Project	<b>IEEE 802.16 Broadband Wireless Access Working Group</b> < <a href="http://ieee802.org/16">http://ieee802.org/16</a> >	
Title	<b>Corrections for the MS's Authorization Flow</b>	
Data Submitted	<b>2005-05-04</b>	
Source(s)	Seokheon Cho Sungcheol Chang Chulsik Yoon,  ETRI  161, Gajeong-dong, Yuseong-Gu, Daejeon, 305-350, Korea	Voice: +82-42-860-5524 Fax: +82-42-861-1966 <a href="mailto:chosh@etri.re.kr">chosh@etri.re.kr</a>
Re:	IEEE P802.16e/D7	
Abstract	The existing PKMv2 is somewhat unorganized and insecure security framework. This contribution provides a resolution for unorganized and insecure MS's authorization flow in the PKMv2.	
Purpose	Adoption of proposed changes into P802.16e/D7	
Notice	This document has been prepared to assist IEEE 802.16. It is offered as a basis for discussion and is not binding on the contributing individual(s) or organization(s). The material in this document is subject to change in form and content after further study. The contributor(s) reserve(s) the right to add, amend or withdraw material contained herein.

## Corrections for the MS's Authorization Flow

## Proposed Changes into IEEE P802.16e/D7

#### 0.1 IEEE P802.16e/D7 Status

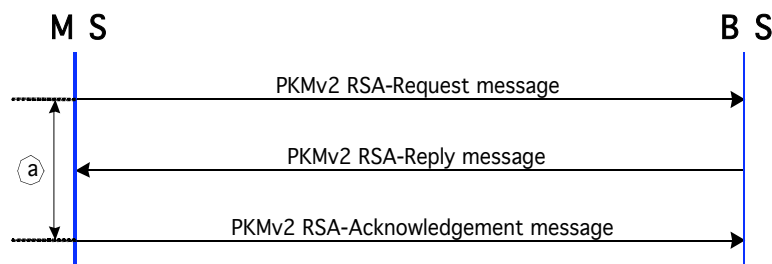
The AK is derived from the PAK or/and the PMK. The PAK and the PMK are obtained from the RSA-based Authorization procedure and the EAP-based Authorization procedure, respectively.

- \_ For the RSA-based Authorization procedure:
  - The Authorization Request message and the Authorization Reply message in the RSA-based Authorization procedure are in the same rank as the EAP Transfer message in the EAP-based Authorization procedure. The Authorization Request/Reply messages contain Security-Capabilities, SAID, and SA-Descriptors, but the EAP Transfer message doesn't contain those parameters.

- The sequence number and lifetime included in the RSA-based Authorization procedure are not an AK sequence number and AK lifetime.
  - When the RSA-based Authorization procedure is selected, there is no message for informing the MS's authentication failure from BS to MS and the BS's authentication result (such as success or reject) from MS.

b) For the EAP-based Authorization procedure:

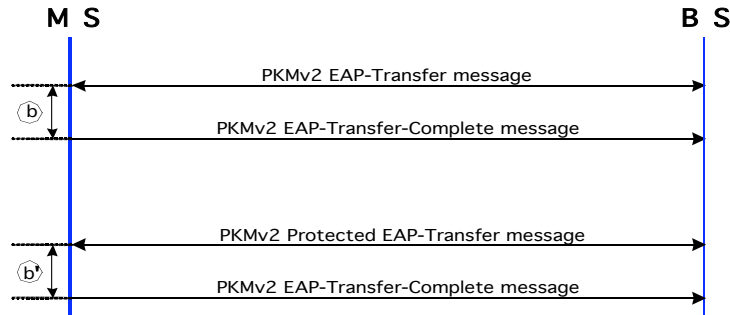
- The messages used in the EAP-based Authorization procedure are as follows
- The Key Sequence Number used in the PKMv2 Authenticated EAP-Transfer message is not an AK sequence number but PAK sequence number.
- In order that BS knows the completeness time of EAP-based Authorization procedure in case that EAP protocol doesn't yield AAA-key and whether a MS receives the last EAP Transfer message (such as "EAP Success" used in EAP-TLS) or not, an MS shall send the PKMv2 EAP-Transfer-Complete message to report EAP-based Authorization completeness. Therefore, both MS and BS can synchronize the AK.

- PKMv2 EAP-Transfer message: EAP Payload
- PKMv2 Authenticated EAP-Transfer message: Key Sequence Number (PAK), EAP Payload, OMAC Digest (from EIK)
- PKMv2 EAP-Transfer-Complete message:
